Sierra Vista Acres Replat A

City Plan Commission — May 22, 2025

CASE NUMBER/TYPE:	SUSU25-00042 – Resubdivision Combination
CASE MANAGER:	Myrna Aguilar, (915) 212-1584, AguilarMP@elpasotexas.gov
PROPERTY OWNER:	EAST FM Sierra Vista Holding Company, LLC
REPRESENTATIVE:	SLI Engineering, Inc
LOCATION:	North of Dyer St. and East of Gateway North Blvd. (District 2)
PROPERTY AREA:	2.11 acres
VESTED RIGHTS STATUS:	Not Vested
PARK FEES:	\$2,100.00
EXCEPTIONS/MODIFICATIONS:	Yes, see following section
ZONING DISTRICT(S):	C-3/c (Commercial/conditions)

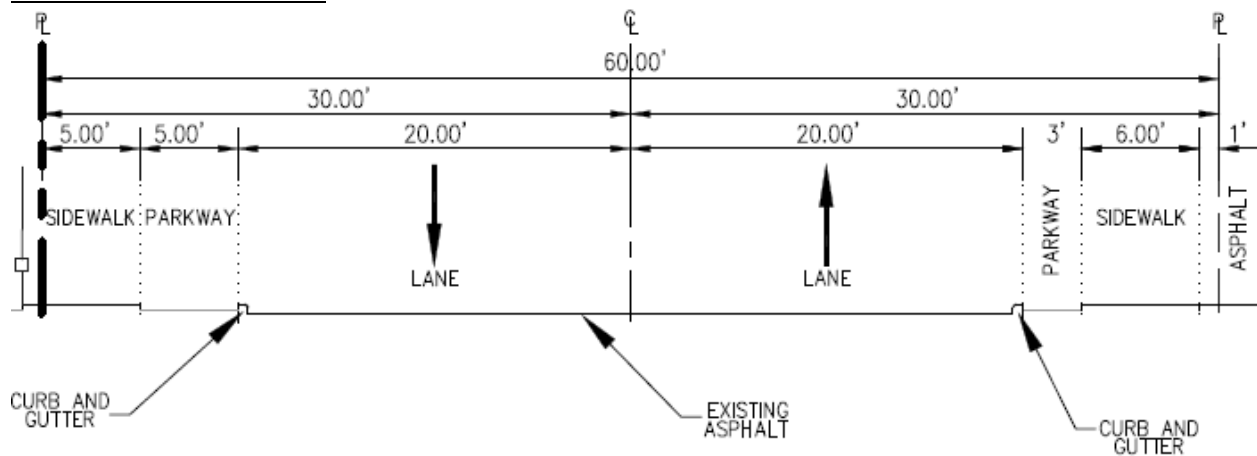
1. To waive the construction of one-foot (1') of sidewalk along Tetons Drive.
2. To waive the construction of one-foot (1') of planter strip along Tetons Drive.
3. To waive the dedication of one-foot (1') of additional right-of-way along Tetons Dr.

EVALUATION OF EXCEPTION REQUEST: The exception requests to waive right-of-way improvements meets the following criteria under El Paso City Code 19.10.050 (A)(1)(a) – (Roadway Participation Policies – Improvement of Roads and Utilities Within and or Abutting the Subdivision). The section reads the following:

The City Plan Commission may waive such requirements to provide rights-of-way or street improvements to adjacent substandard roads based on any of the following factors:

a: Fifty per cent of the lots within a quarter mile of the proposed development have already been developed and the existing street improvements are in character with the neighborhood.

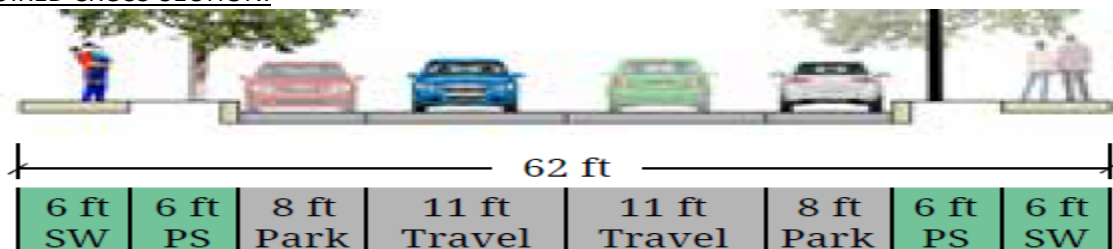
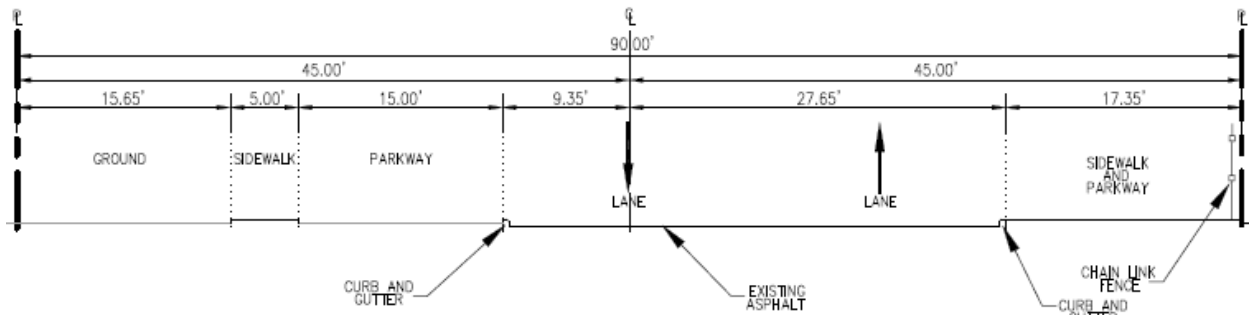
4. To waive the construction of one-foot (1') of sidewalk along Lawrence Ave.

ATTACHMENT 2

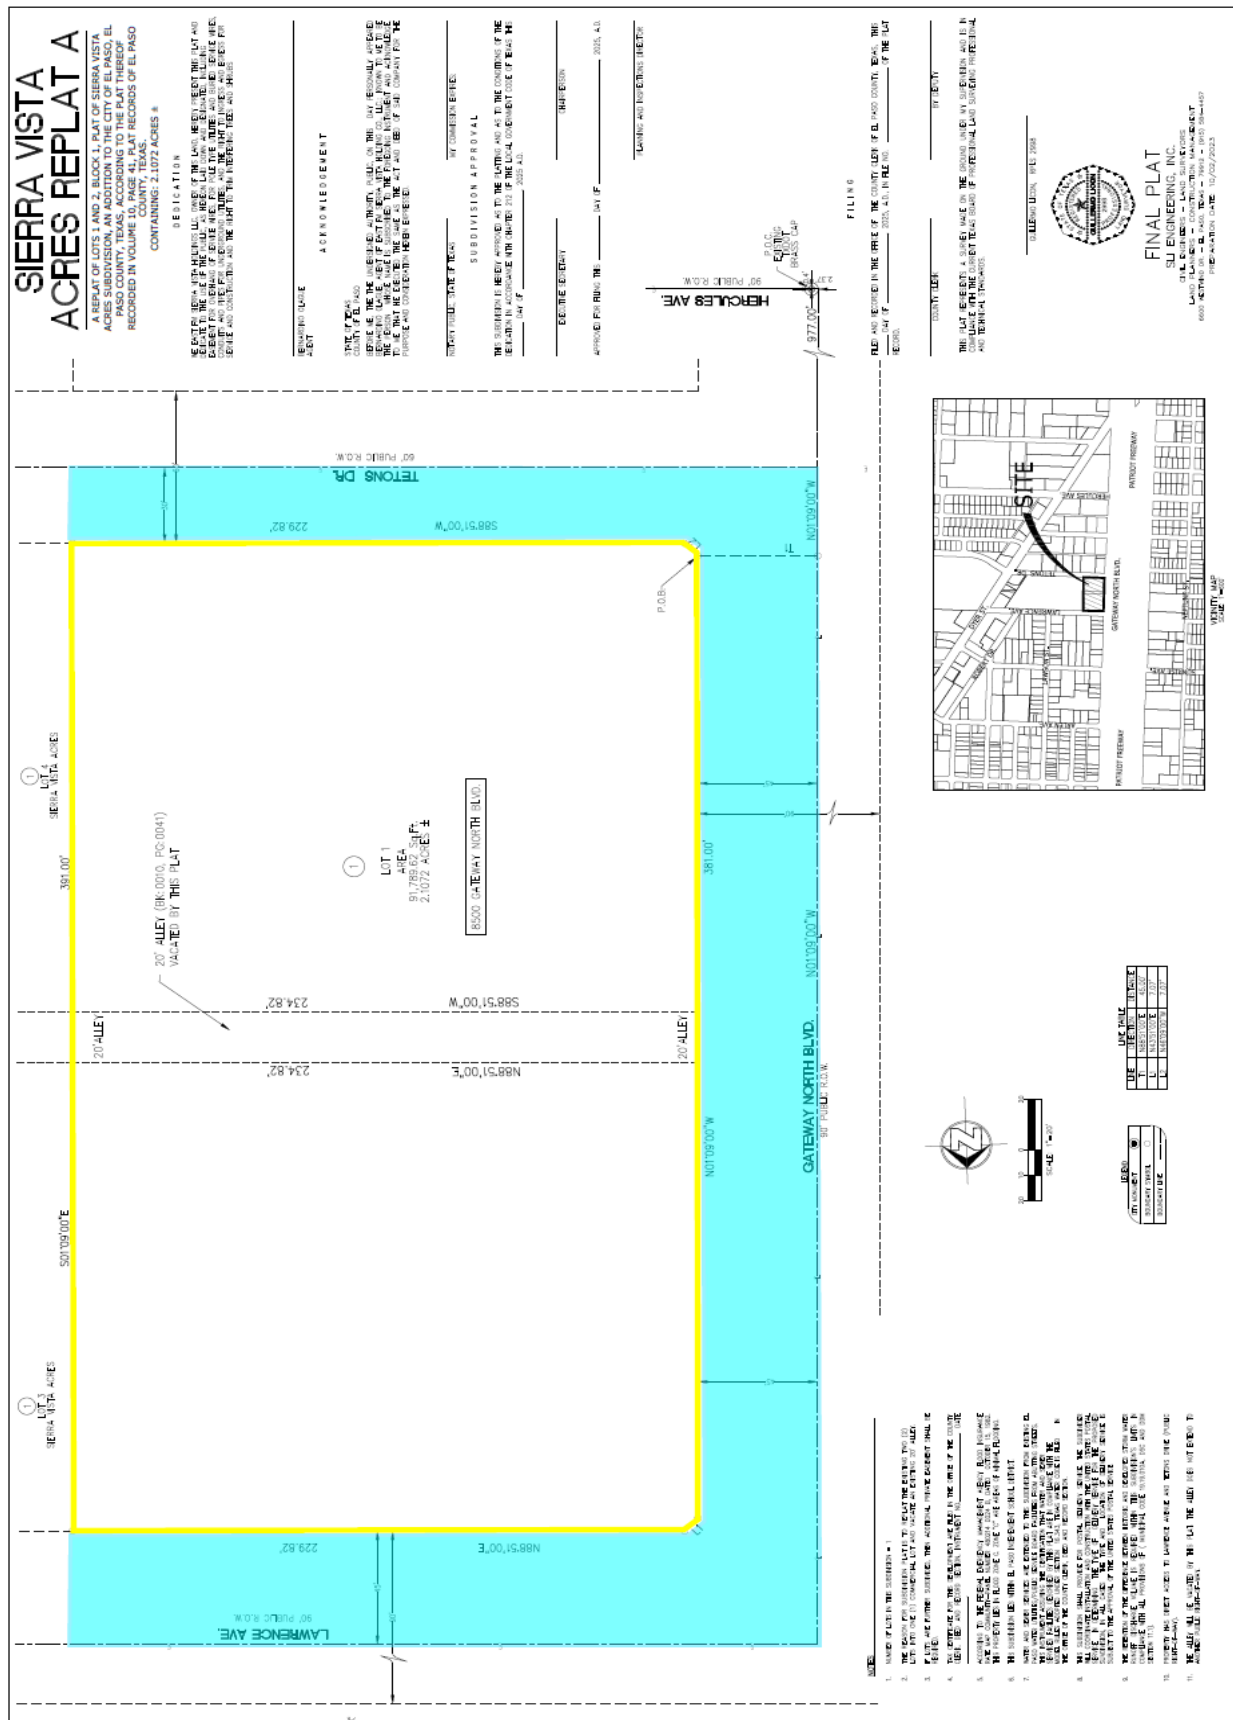
2. Provide print-out of the mathematical closure of the exterior boundary of the subdivision indicating the error of closure.
3. Add general note to both the preliminary and final plat sheets: "The retention of all storm-water runoff discharge volume is required within this subdivision's limits in compliance with all provisions of (Muni-Code 19.19.010A, SDM, and DDM Section 11.1)."

4. Provide water flow into on-site ponding with arrows. Show existing and proposed drainage flow patterns on the preliminary plat. Identify the discharge location for all stormwater runoff. Approximate location of areas subject to inundation or stormwater overflow, and direction of flow of all watercourses.

5. Provide and label On-site ponding notes on Preliminary and Final plat.
6. The proposed ponding areas for subdivision shall have enough capacity to hold the developed runoff for a designated 100-yr. storm event, provide drainage calculations.

8. Provide and label private drainage easement in case needed.

Please add a 10' wide easement along all lot lines of the property, we have existing lines throughout the property.
